Service Letter SL-0003

Subject: Wiring Improvements

Affected Model(s): E1000

Figure 1: Wiring Improvements

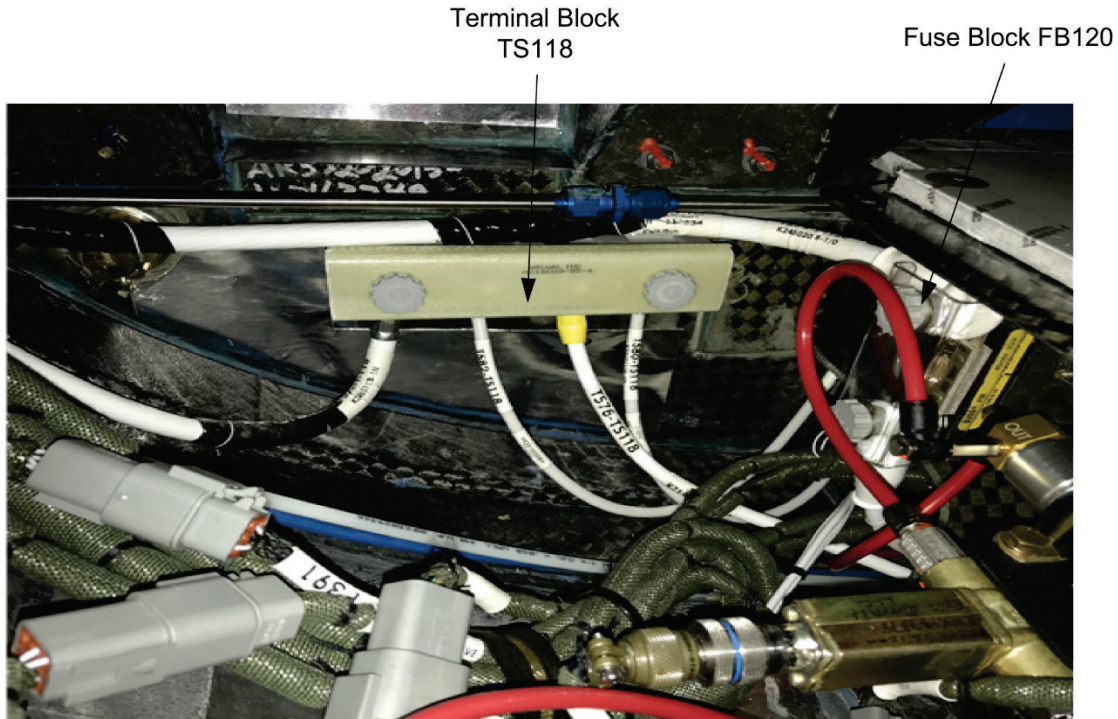
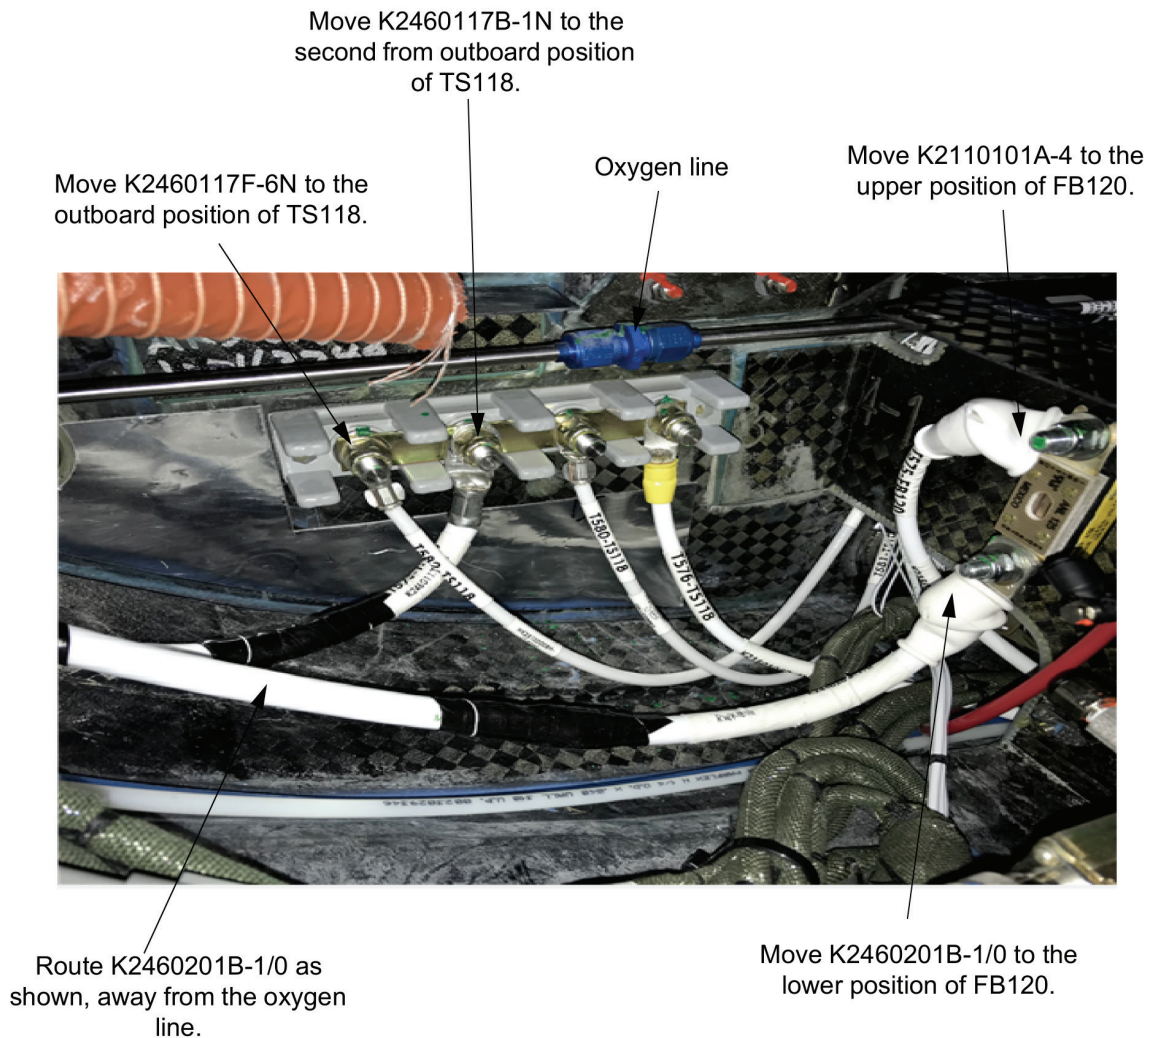
- a) Remove the fuse block cover (Refer to Figure 1).
- b) Disconnect the terminal end of K2460201B-1/0 from the upper terminal of fuse block (FB120).
- c) Disconnect the terminal end of K2110101A-4 from the lower terminal of fuse block (FB120).
- d) Connect the terminal end of K2110101A-4 from the upper terminal of fuse block (FB120).
- e) Connect the terminal end of K2460201B-1/0 from the lower terminal of fuse block (FB120).
- f) Make sure power wire K2460201B-1/0 is routed below the terminal block (TS118), away from the oxygen line (Refer to Figure 2).
- g) Install the fuse block cover.

- a) Remove the terminal block cover (Refer to Figure 1).
- b) Disconnect K2460117B-1N from the outboard terminal stud.
- c) Disconnect K2460117F-6N from the second from outboard terminal stud.
- d) Connect K2460117F-6N to the outboard terminal stud.
- e) Connect K2460117B-1N to the second from outboard terminal stud.
- f) Make sure the wires are routed for the correct minimum bend radius (Refer to Figure 2).
- g) Install the terminal block cover.

New Configuration
(Shown with terminal block and fuse block covers removed.)
